RFP#16-18 FOUNDRY PLACE PARKING GARAGE PERCENT FOR ART PROJECT PORTSMOUTH, N.H. December 14, 2017 Addendum#3

This Addendum forms part of the original document marked: RFP#16-18 Foundry Place Parking Garage Percent for Art Project.

A-547

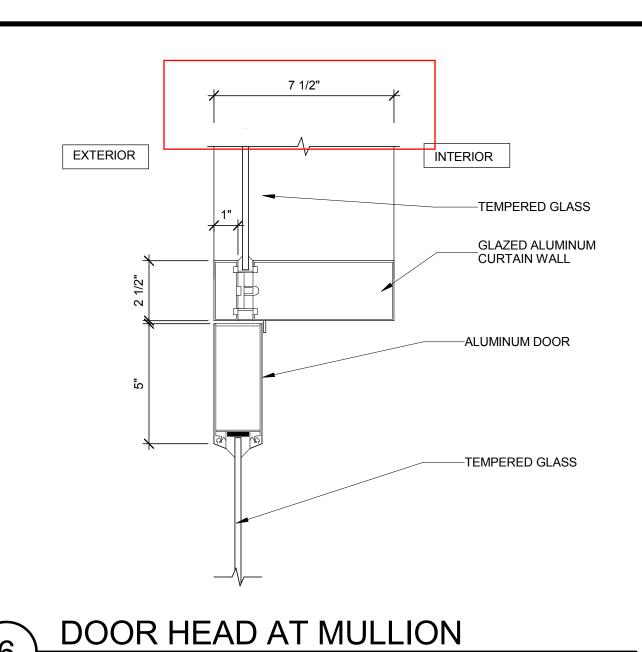
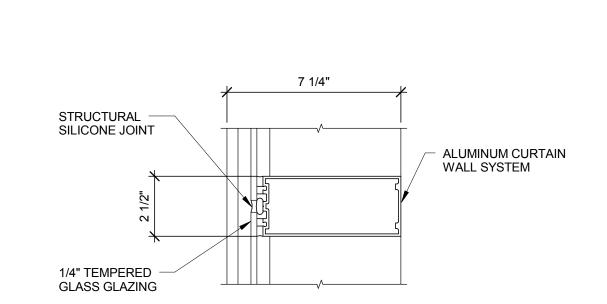
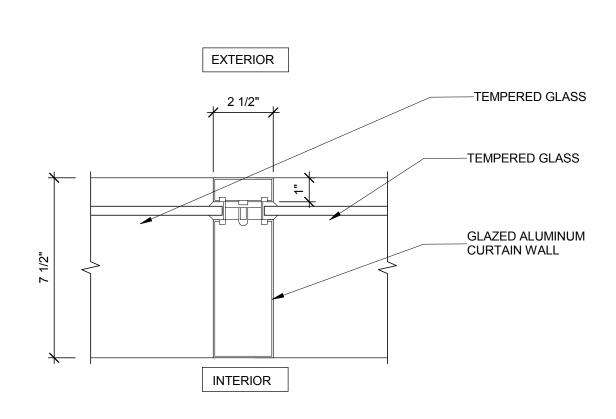
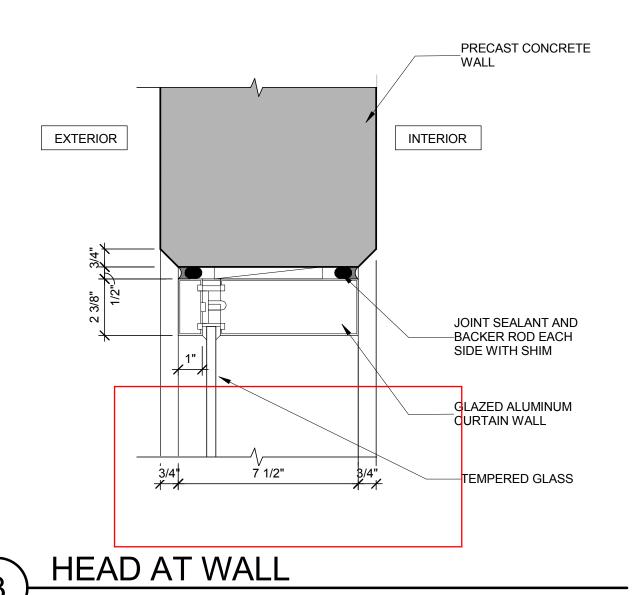
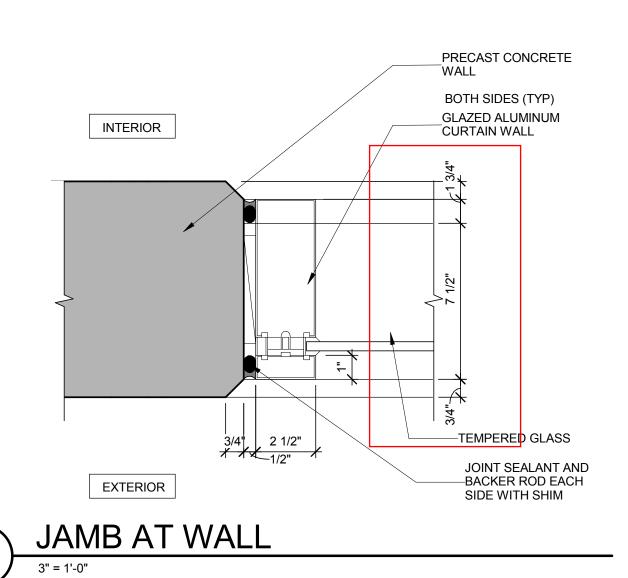
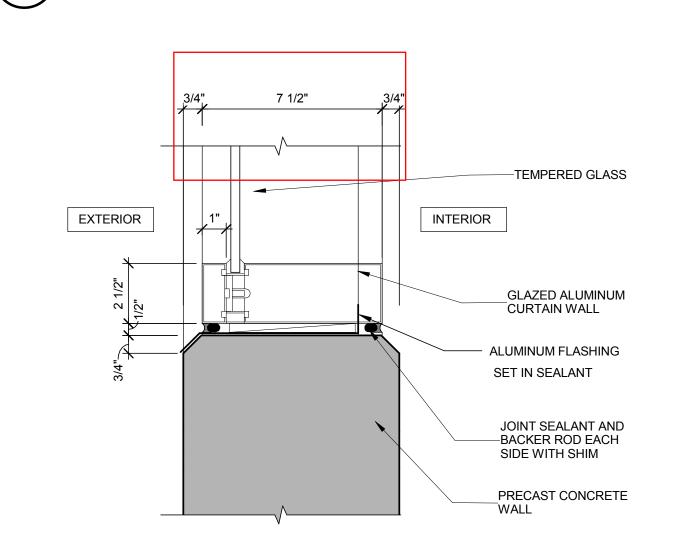
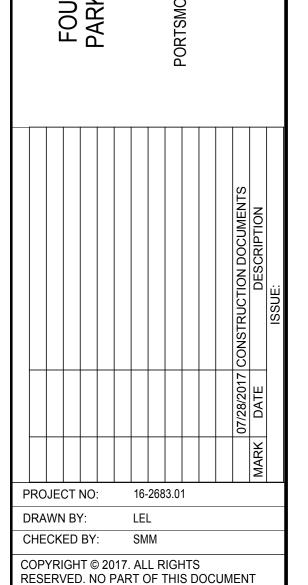
- Q: Can the installer of the curtainwall system specify an offset distance (or anticipated range of offset distances) between the concrete landings in stairwell A and the glass curtainwall? See attached excerpt from construction drawing A-410.

- A: D|A: Refer to drawings A-547 for further information regarding depth of mullions at the Stairwell A.
- Q: Understanding the DSA civic space may or may not be available for installed works, are plans for this lot available that will describe the anticipated layout of this "green space"?

DESIGN DEVELOPMENT - PROGRESS JANUARY 10, 2017

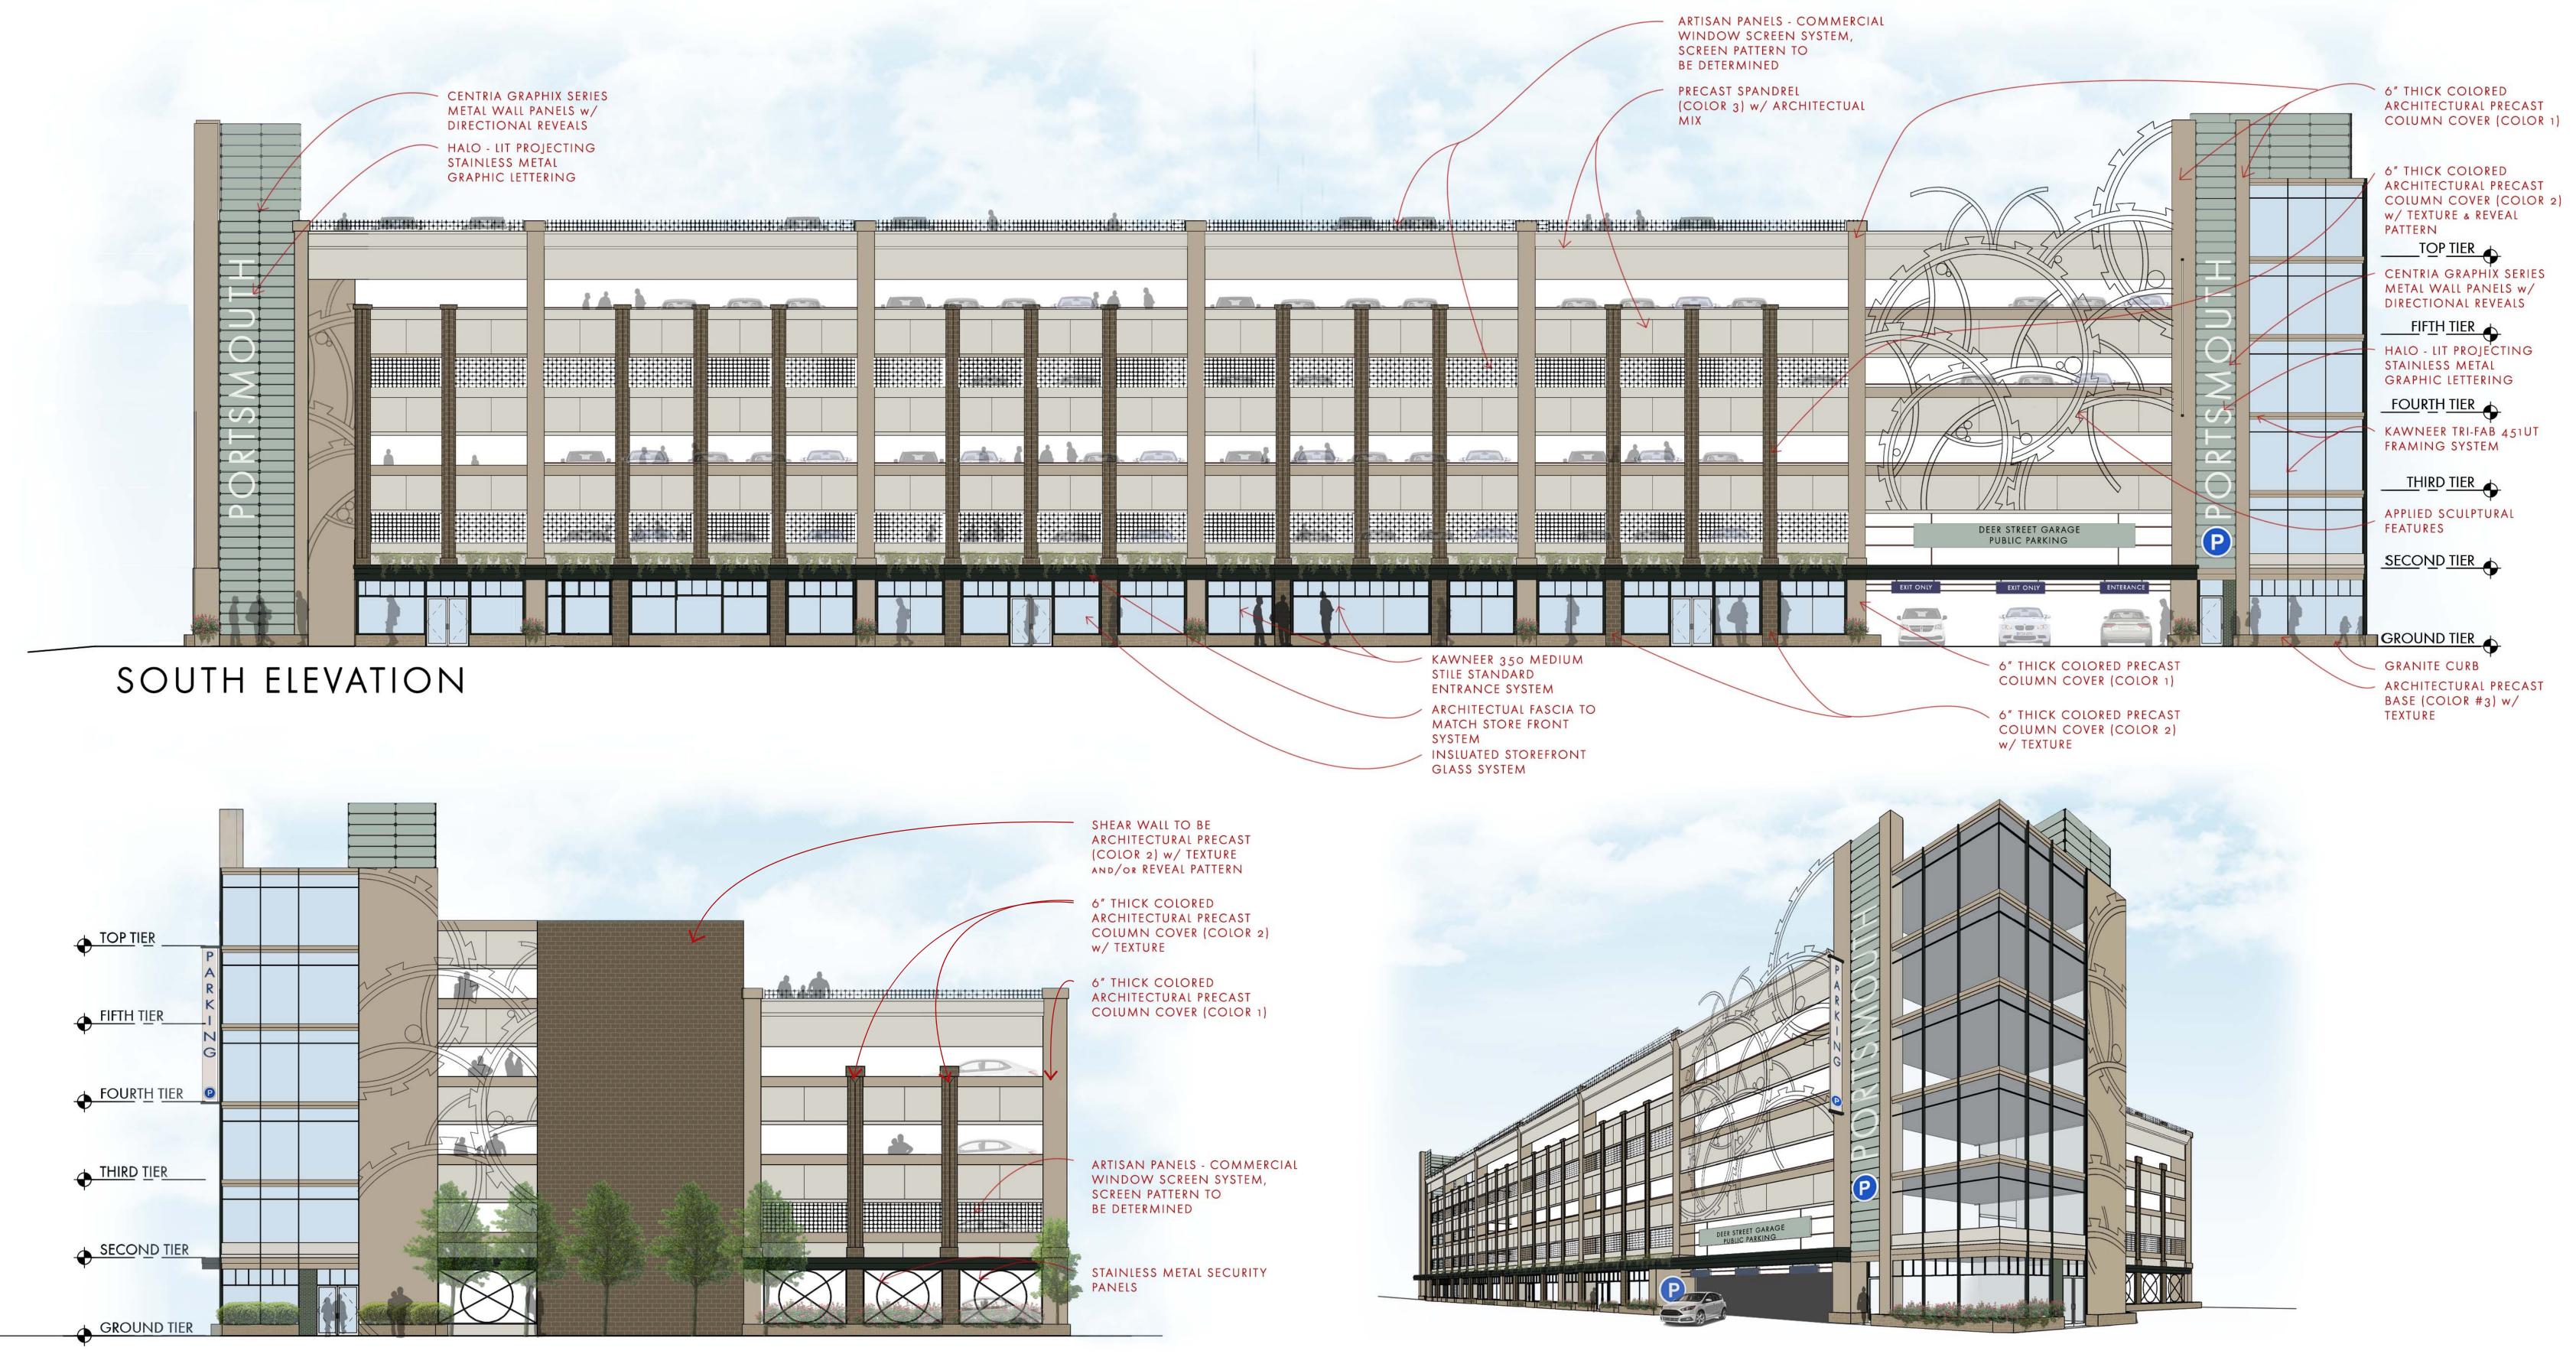
- Q: Are specifications for the windows to be used on Stairwell A available? Will the glass utilize antiglare and/or anti-reflective surfaces? If not, is it acceptable to install anti-glare and/or anti-reflective coatings or films to the interior/exterior of these windows?
- A: D|A: The architectural spec of the window system used at Stairwell A are as follows: (as from the Design Development)

Kawneer Tri-Fab 451 UT Framing system. Please refer to the provided design development diagram.

D|A: The architectural drawings have not determined an anti-glare/anti-reflective film on the glass.
